MEMO

Re: 3rd Review for new construction at 158 S. HIGH STREET

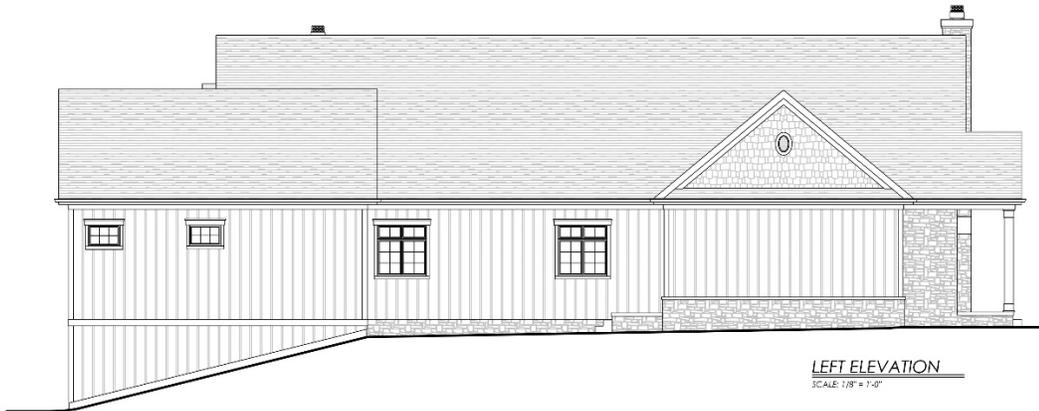
4. Earlier façade proposal with the porte-cochere, which is out of place and inappropriately sized.

5. Re-designed façade with porte-cochere removed for a rear-load garage, a lower front gable, and an enlarged screen porch. The hyphen connecting the garage should have a stone foundation and the “bump-out” to the right (south elevation) should be removed.

6. Sketch of front elevation with stone foundation in the hyphen, simplified front gable, removal of right “bump-out” and height of screen porch slightly reduced to align with the hyphen.

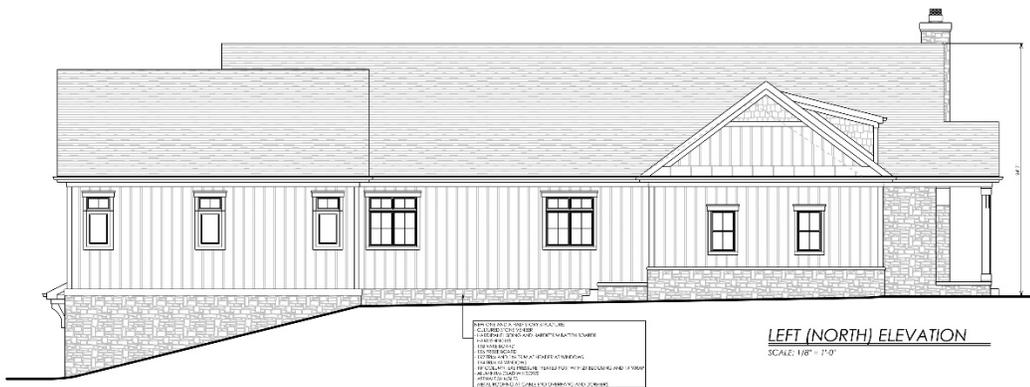
7. Earlier north (left) side elevation with porte-cochere and a few mis-matched windows.

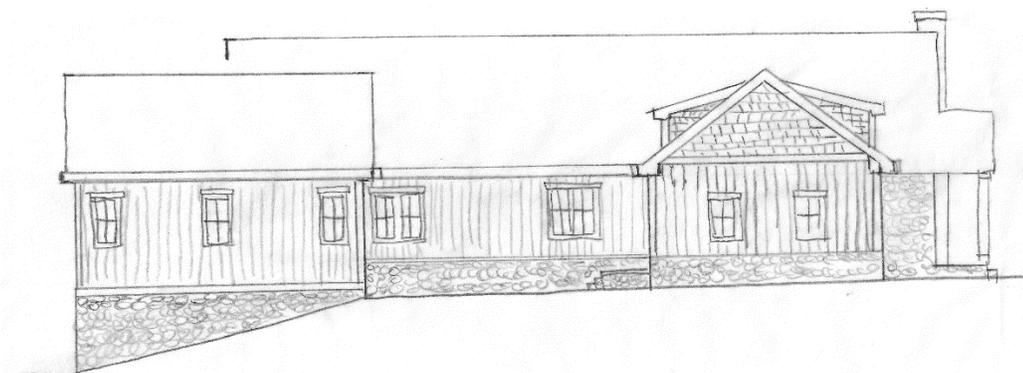
8. Re-designed north side elevation with porte-cochere removed for a rear-load garage and added windows. The windows should be of a similar size and style while the garage needs a rear shed dormer for symmetry. The height of the front garage and rear master bedroom/garage should align for balance while the stone water table should be carried through the main portion of the house.

9. Sketch of north side elevation with stone water table continued, shed dormers on both sides of the garage roof, and windows of the same size and type. The gable of the garage has been simplified as well. The roofs of the rear master bedroom/garage and the front garage are now aligned.
